UNITED STATES PATENT AND TRADEMARK OFFICE

APPLICATION NO.	FILING DATE	FIRST NAMED INVENTOR	ATTORNEY DOCKET NO.	CONFIRMATION NO.
10/524,763	04/26/2005	Matthias Muller	NY-DNAG-300-US	3415
24972	7590	05/03/2006	EXAMINER	
FULBRIGHT & JAWORSKI, LLP 666 FIFTH AVE NEW YORK, NY 10103-3198			ADDISU, SARA	
			ART UNIT	PAPER NUMBER
			3722	
DATE MAILED: 05/03/2006

Office Action Summary	Application No. 10/524,763	Applicant(s) MULLER ET AL.	
	Examiner Sara Addisu	Art Unit 3722

DETAILED ACTION

**FIG. 2**

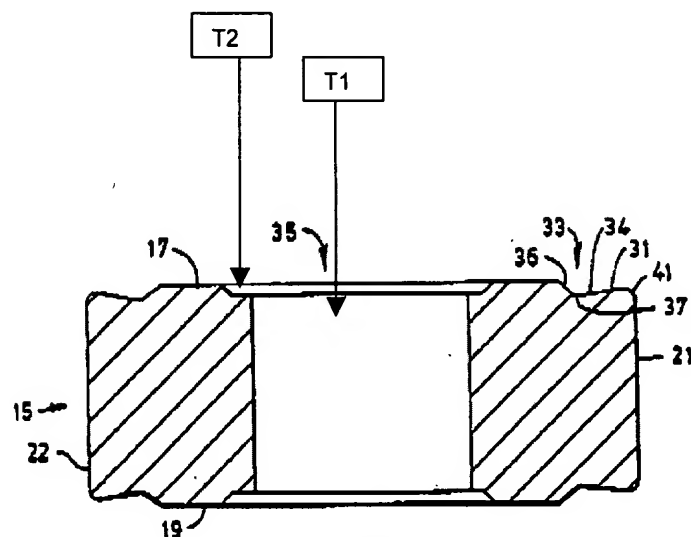
Regarding claim 11, KATBI ET AL. teaches a cutting plate (15) comprising an upper side (17), a first clamping trough (T1: through hole part of opening 35), a cutting edge, a second clamping portion (T2: see figure below) arranged coaxially with respect to the first clamping trough ('061, figure 2). The first clamping trough (T1) is deeper than the second clamping portion (T2). KATBI ET AL. also teaches in figure 2, both troughs (T1, T2) being arranged such that they are deeper than upper surface (17). Regarding claim 12, KATBI ET AL. teaches in figure 1, both clamping troughs being round.

Regarding claims 17, 23 and 24, as shown in the figure below, T2 forms an annular surface that is parallel to the upper side (17). Regarding claims 29, 30, 35, 36, 41, 42, 47, 48, 53, 54, 59, 60 and 65, KATBI ET AL. teaches an indexable ceramic insert.

KATBI ET AL. teaches a cutting plate (15) comprising an upper side (17), a first and second clamping trough (T1, T2), as set forth in the above rejection. Furthermore, regarding claims 19-22 and 25-28, as shown in the figure above, T2 forms an annular surface that is parallel to the upper side (17). Regarding claims 31-34, 37-40, 43-46, 49-52, 55-58, 61-64 KATBI ET AL. teaches an indexable ceramic insert. Regarding claim
